**COMMENTS ON PLANNING STRATEGY – EAST OF ABERLINE, WARRNAMBOOL
(draft Amendment C217 of the Warrnambool Planning Scheme and accompanying documents)**

COMMENTS ON PLANNING STRATEGY – EAST OF ABERLINE, WARRNAMBOOL

(draft Amendment C217 of the Warrnambool Planning Scheme and accompanying documents)

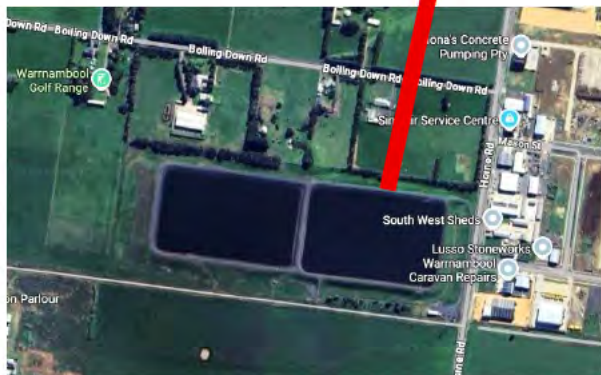
The modelled EVC mapping (Naturekit, *image right*) of the area suggests that there are scattered areas of native vegetation, but this is rarely the case. Most of the modelled patches are plantations of introduced species, particularly cypresses and non-indigenous eucalypts. These have multiple values for wildlife (e.g. roosting, nesting, food, shelter), but in no way conserve the breadth of flora and fauna which once inhabited the district.

Looking more closely at the proposed development site, the errors in the EVC mapping are more obvious (*images over the page*).

- Only small parts of Tozer Reserve mapped as Plains Grassy Woodland – much of the Reserve is native vegetation which is Plains Grassy Woodland or a recovering form of it
- Trees on north side of Wangoom Rd mapped as Plains Grassy Woodland – actually cypress plantations
- Large square area to south of area mapped as Plains Grassy Woodland – actually water retention basin.

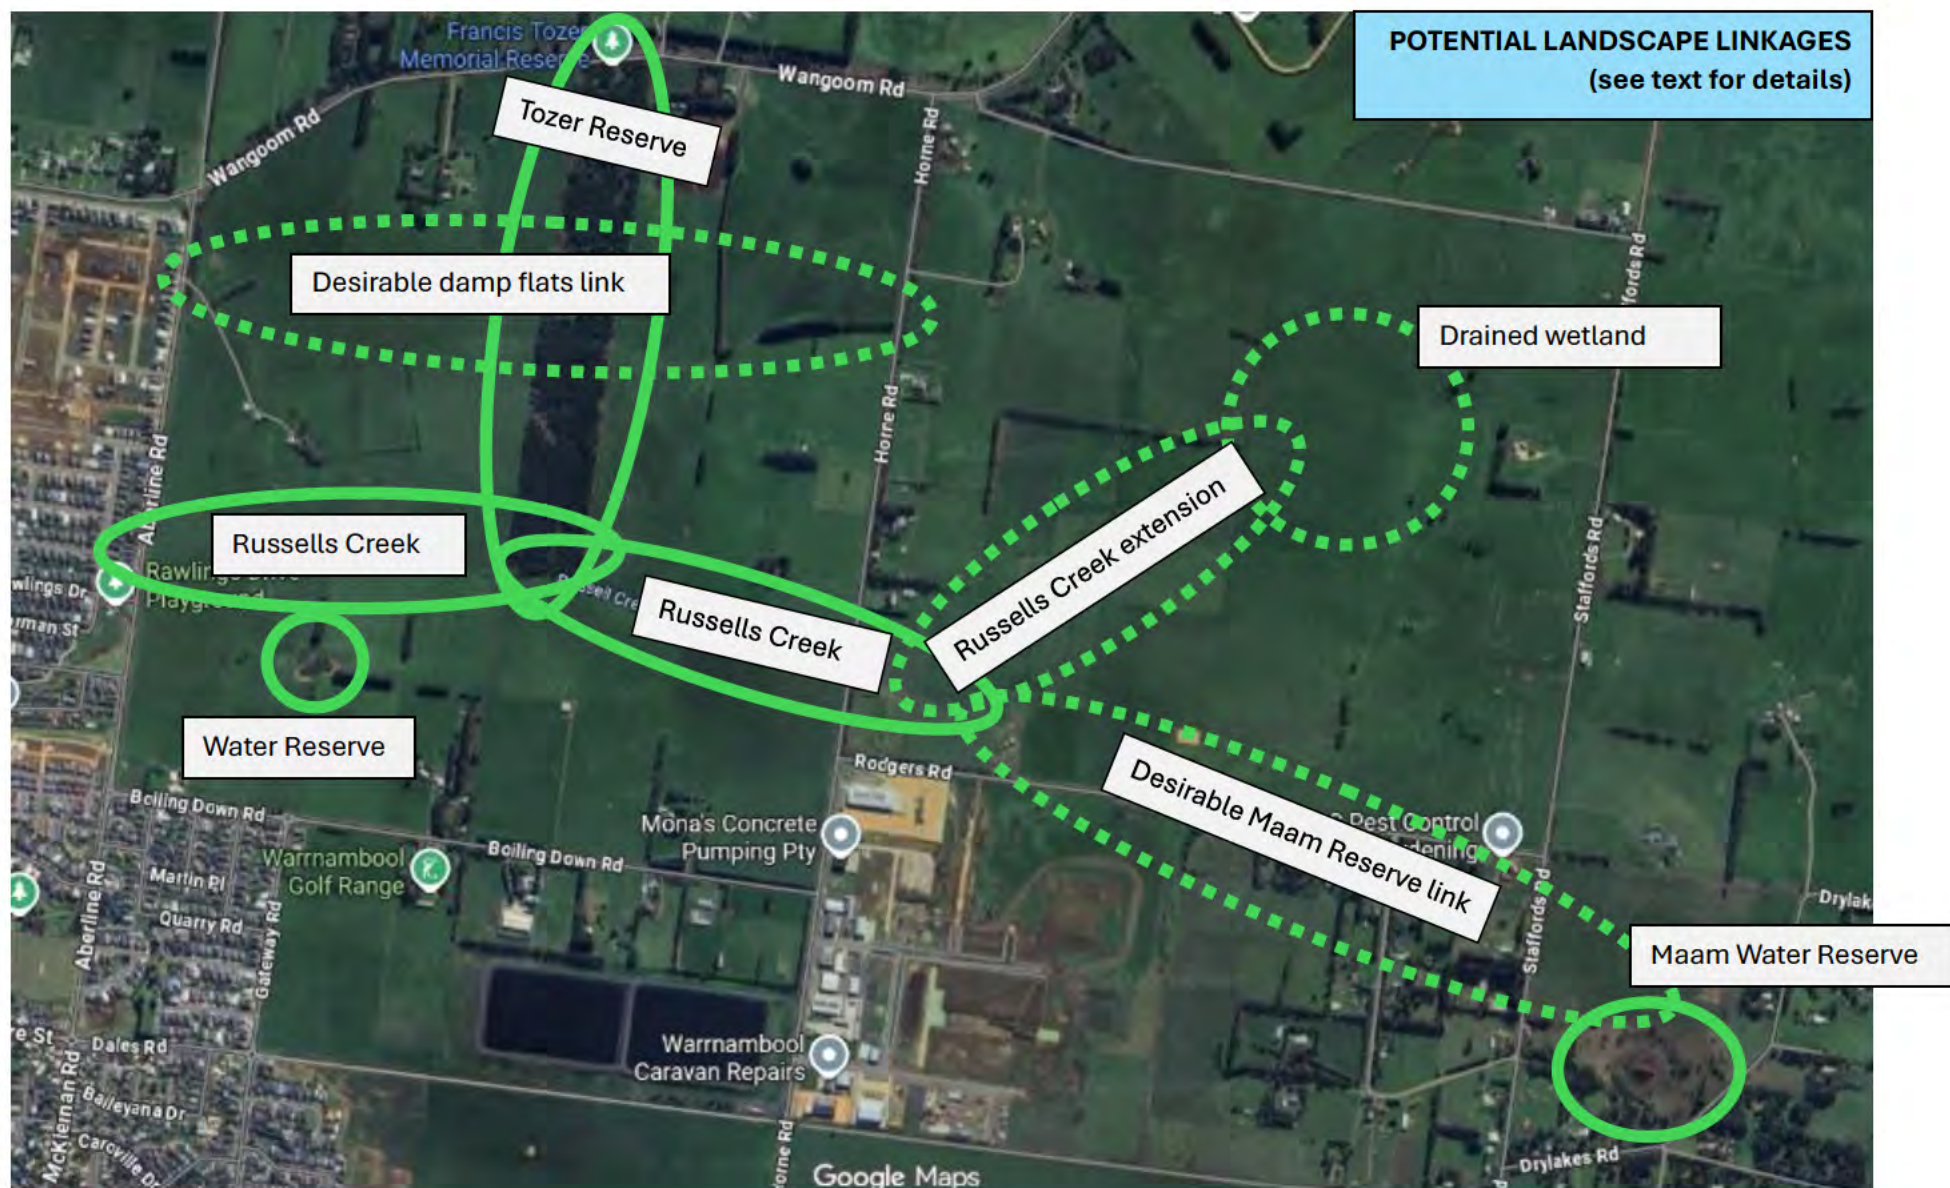
There is a 1.92 ha area of Crown land at 43 Boiling Down Rd which includes a water body ([Historical Photo-Maps Image right](#)). Aerial photographs show a waterbody which is unfenced and being treated like part of the farmers paddock. It is currently zoned FZ (farming zone [Planning property report](#)).

The fact that this waterbody contains water without any obvious inputs indicates it is probably spring fed.

Historic photos (Appendix 3) show water persisted in this area during the Millenium drought when many other waterbodies dried up.

The photo taken on 12/7/2013 (*lower image*) shows cultivation avoided the wet area that extends beyond the main water body.

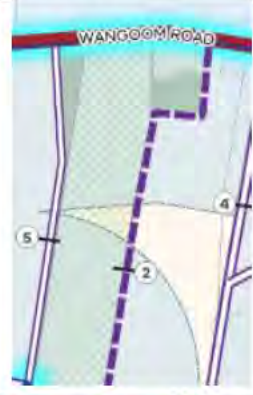
G6 Where affordable housing is provided, affordable housing products should be predominately located in higher amenity areas close to services, public transport and community facilities and provide for a range of housing typologies to meet demonstrated local needs having consideration to Table 1 Housing density and diversity. (T4)	Supported.	
G8 Specialised housing forms, such as lifestyle communities, retirement living, or aged care	Supported.	Include housing for single people, including single

PSP Document	Response	Suggested improvements
		women. This type of housing has particular needs. • Include disability housing.
Table 1 Housing density and diversity	Housing to four storeys is proposed.	• Housing to four storeys is proposed. Housing of this density should be balanced by more open space areas, including places for passive recreation and meeting places (not just playgrounds). • Housing for families should include housing for non-nuclear families. Larger lots do not automatically create a 'strong community setting'. Places where kids can safely play beyond their home, as well as safe walking and bike-riding are important. • Large lots can encourage large houses, rather than more space for kids. Place limits on the footprint and total floor area (including paving) of houses. • Higher development also needs to consider shading, water management, and space for vegetation to

Plan 11 Precinct Infrastructure Plan East of Aberline Precinct Structure Plan 		•

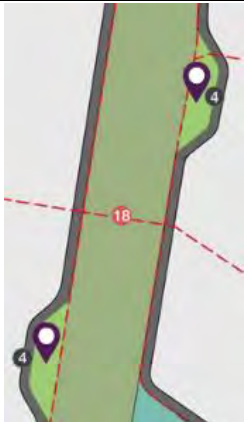
PSP Document	Response	Suggested improvements
	Local parks have been located adjacent to Tozer Reserve and to proposed main access roads. This is not appropriate for conservation, access, and safety reasons.	- Local parks should be located within the residential area, and away from main access roads to ensure the safety of pedestrians. - Local parks should be located within residential area, and away from Tozer Reserve to reduce disturbance to conservation values.
	Water retarding basins are located only at the bottom of the catchment, and adjacent to (or on) the flood plain of Russells Creek. Stormwater treatment should occur throughout the subdivision, not just at the 'bottom'. There is a risk of floodwaters scouring out the sediment of retarding basins and distributing it into Russells Creek, and then to the Merri River. Riparian buffers for Russells Creek are too narrow. The 43 Boiling Down Rd Water Reserve has been ignored in planning when it could become an important conservation and aesthetic area in the lower part of the subdivision.	- Integrate stormwater treatment throughout the subdivision to reduce the load, and necessity, for retarding basins on floodplains. - Use 100 m wide riparian buffers to provide excellent protection for the waterway. - Plan for the protection and restoration of the wetland/spring within the Water Reserve, including riparian vegetation, and a biolink to Russells Creek.

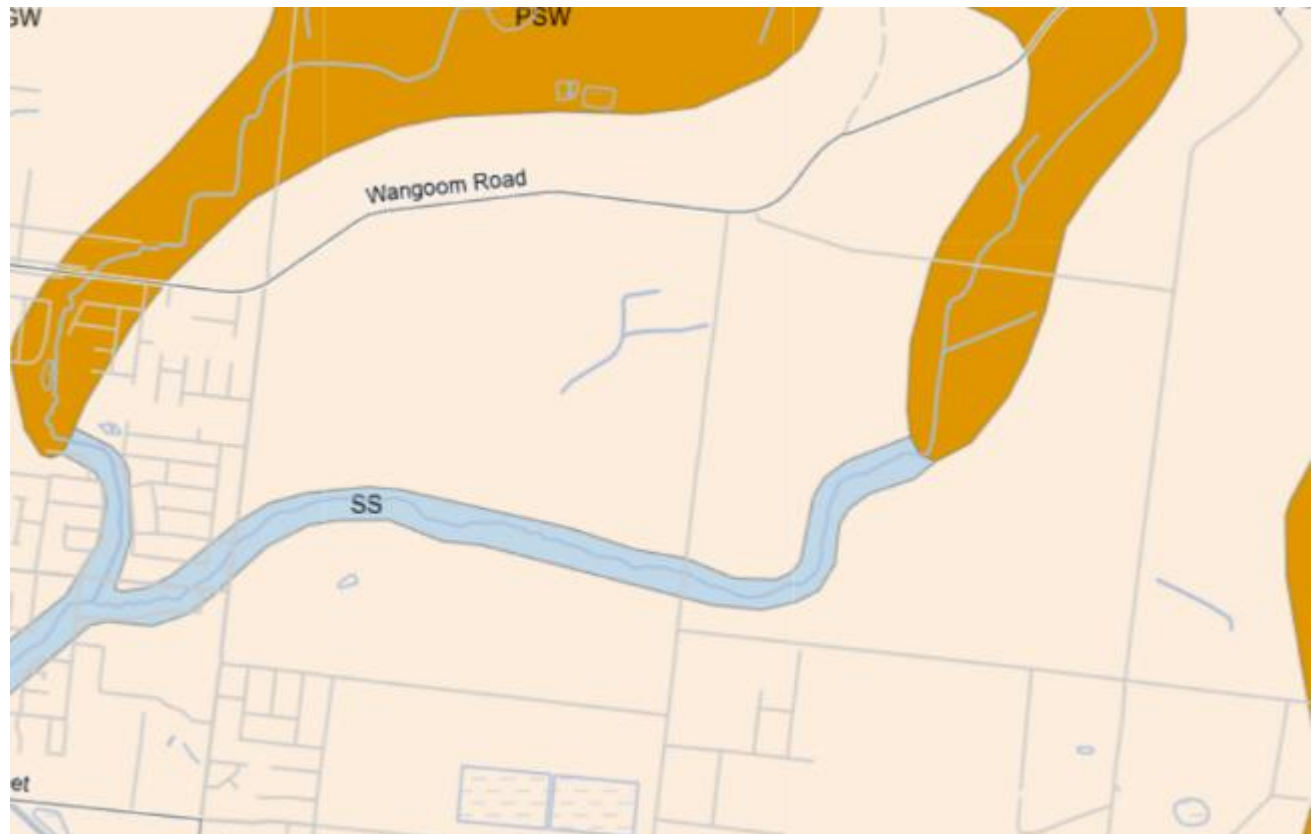
5.7 Infrastructure co-ordination 5.7.1 Staging and location of development	Experience of the subdivisions between Wollaston Road and the Merri River shows that developers tend to completely bare off a site, exposing soil and creating erosion. This is highly undesirable. At those sites, water retention basins were also constructed very late in the subdivision so that sediment flowed and blew into the Merri River.	• Staging of the subdivision is extremely important for conserving the values of Tozer Reserve, Russells Creek, and the Water Reserve. • Specify that sediment treatment and water slowing infrastructure be installed throughout the development (not just at the bottom), and be completed very early in the development so that

Statement in PSP - Background Report Draft report	Response	Suggested improvements
	This continues during the house construction phase.	sediment and water are appropriately managed.

[Viewing Map 6092](#)

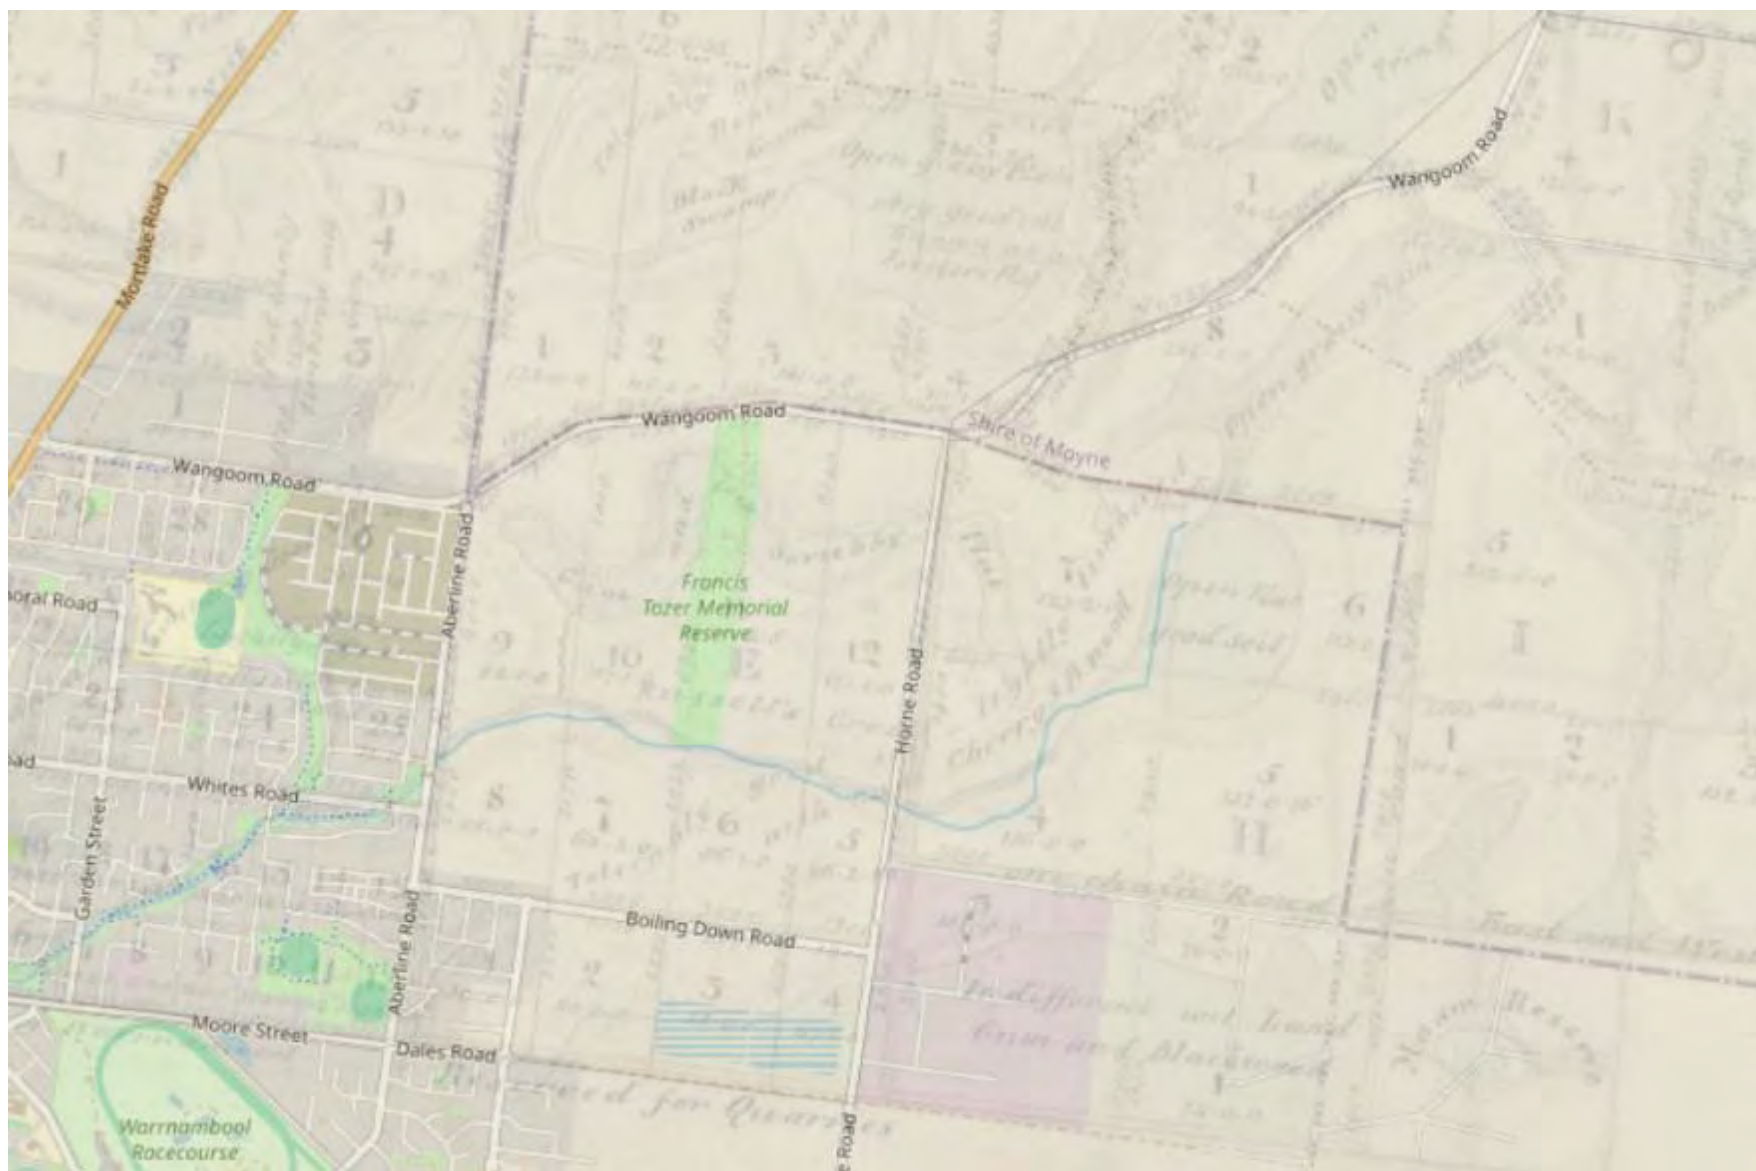
Shows open flats and other vegetation detail in proposed development area. These may have been developed by Maar cultural practices (e.g. burning) or subtle differences in wetness/soil.

There is also a wetland identified as 'Black Swamp' to the north of the proposed development area.
